## **SOUTHERN DOWNS REGIONAL COUNCIL SPECIAL MEETING OF COUNCIL**

##### 4.1 Consideration of Change Representations - Lucas Riley, 14135 Cunningham Highway, Rosenthal Heights

<b>Southern Downs</b> REGIONAL COUNCIL	<b>Report To: Special Council Meeting</b>	
	<b>Reporting Officer:</b>	<b>Meeting Date:</b> 3 September 2018
	Planning Technical Officer	<b>ECM Function No/s:</b> MCU\01934

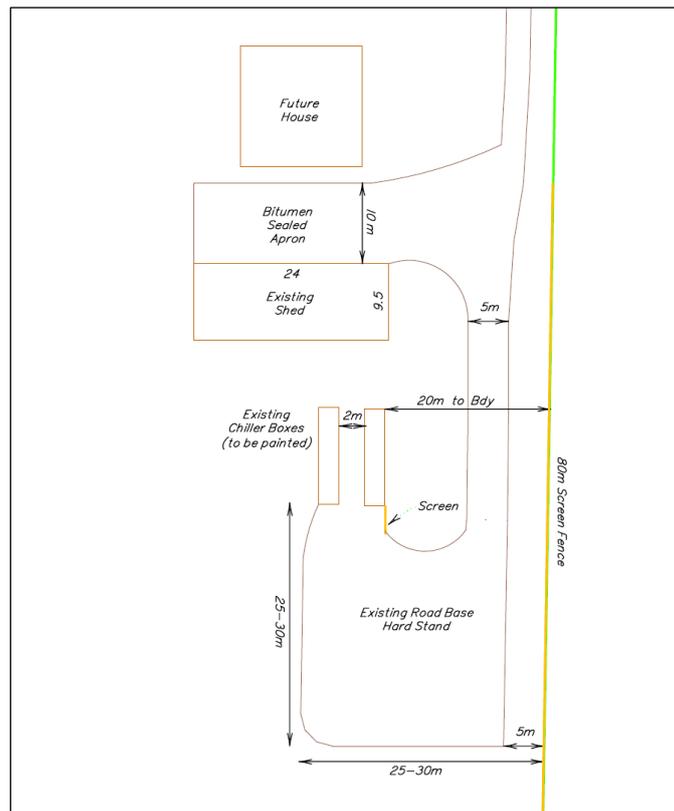
*Views from the eastern side of the site, before and after the chiller boxes have been painted*

*Instead of landscaping, our client proposes to erect a 1.8 metre high screen fence from the front of the shed, to past the chiller boxes, as shown on plan W5345-02. The screen fence will be easy to maintain, won't deteriorate in periods of drought and will provide a screen immediately. This screen fence will ensure that when the vehicles accessing the chiller boxes are turning, there will be no light nuisance to the adjoining property. Given the current weather situation, our client is reluctant to establish a landscaped buffer.*

23. *By 30 October 2018, a 1.8 metre high screen fence is to be erected as shown on W5345-02. The screen fence is to be maintained. ~~200-metre wide landscaped buffer, including mounding of 1.0 metre above ground level and Irrigation, is to be provided~~*

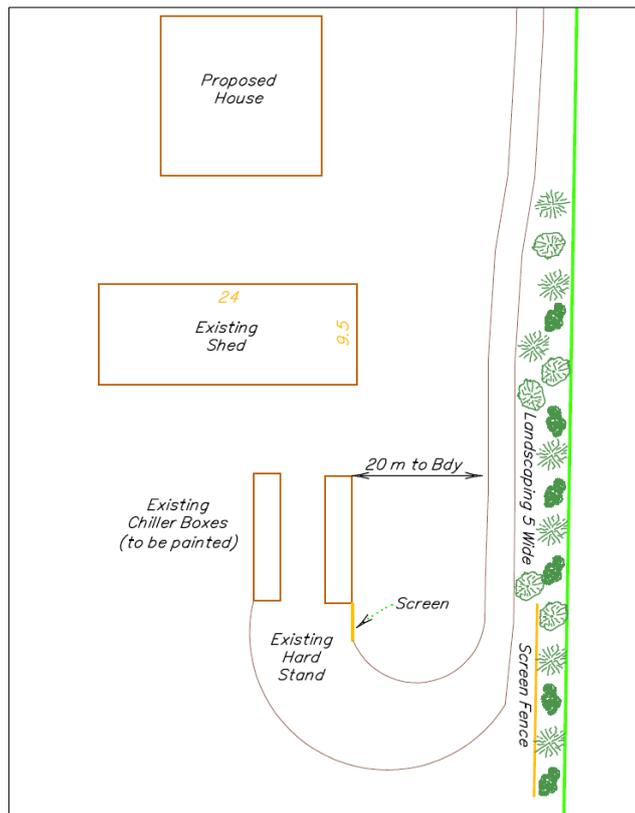
The plan referred to above shows an 80 metre long screen fence commencing approximately 10 metres forward of the shed.

The consultant had previously advised that the applicant wished to provide landscaping along the eastern boundary, and two smaller sections of screen fencing as shown in the plan below.

The provision of a screen fence for a minimum length of 80.0 metres along the eastern boundary as proposed by the applicant is considered reasonable and will reduce the impacts associated with the proposed development. A condition is to be included to require the provision of a screened fence in accordance with the applicant's plan.

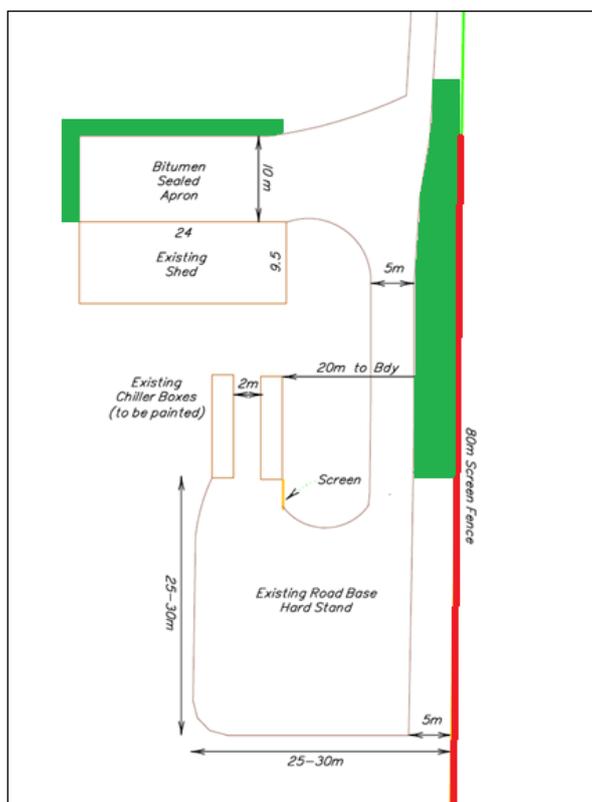
The applicant has painted parts of the shipping containers. The eastern elevation has been painted in a colour similar to the shed, which has significantly reduced the visual impacts associated with these structures when viewed from the east. However, the western side of the containers remain a bright orange which does not allow the structures to blend into the surrounds.

The removal of all landscaping requirements is not supported. Recommendations have been made to allow the parking of vehicles on the northern side of the shed and to allow an increase in the hours of operation for the chiller boxes, and these changes can only be justified if the area is suitably landscaped and screened to mitigate impacts.

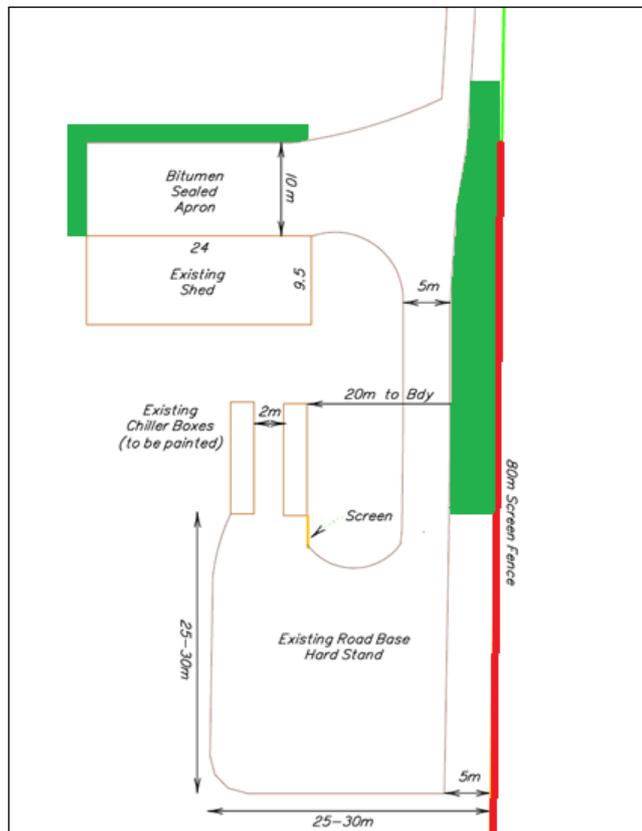
It is recommended that landscaping of the site is required in accordance with the plan below.

The provision of a screen fence along part of the eastern boundary will mitigate some impacts on the adjoining neighbour, however, a 1.8 metre high fence will not provide adequate mitigation of noise and light nuisance. Landscaping is to be provided between the driveway and property boundary extending approximately 15 metres north of the shed, to the rear of the shipping containers.

Subject to the shipping containers being painted the same colour as the shed, it is not necessary to provide landscaping to the south or west of the containers.

Landscaping to the north of the shed will provide screening of the parking area.

It is recommended that Conditions 23, 24 and 25 are amended and Conditions 22A and 22B are included, as follows:

- 23. *By 30 October 2018, ~~a 20.0 metre wide landscaped buffers, including mounding of 1.0 metre above ground level and irrigation, is are to be provided around the workshop and chiller boxes area so as to provide a visual buffer as shown on the plan below. Dense landscaping is to be provided between the driveway and property boundary extending from 15 metres north of the shed to the rear of the chiller boxes. Dense landscaping is also to be provided around the sealed apron north of the shed. This area is~~ These areas are to be densely planted with advanced trees and shrubs, 1.5 metres in height, suitable to grow to heights of between 3.0 to 20.0 metres at maturity. Within the ~~20 metres of this~~ buffer area, random plantings of a variety of native trees and shrubs of differing growth habits are to be provided at spacings of 4-5 metres ~~i.e. 5 row of trees, 5.0 metres apart.~~ The trees and shrubs must be of species that are fast growing, frost resistant and drought hardy. The vegetated buffers are to be maintained so they form an effective buffer.*
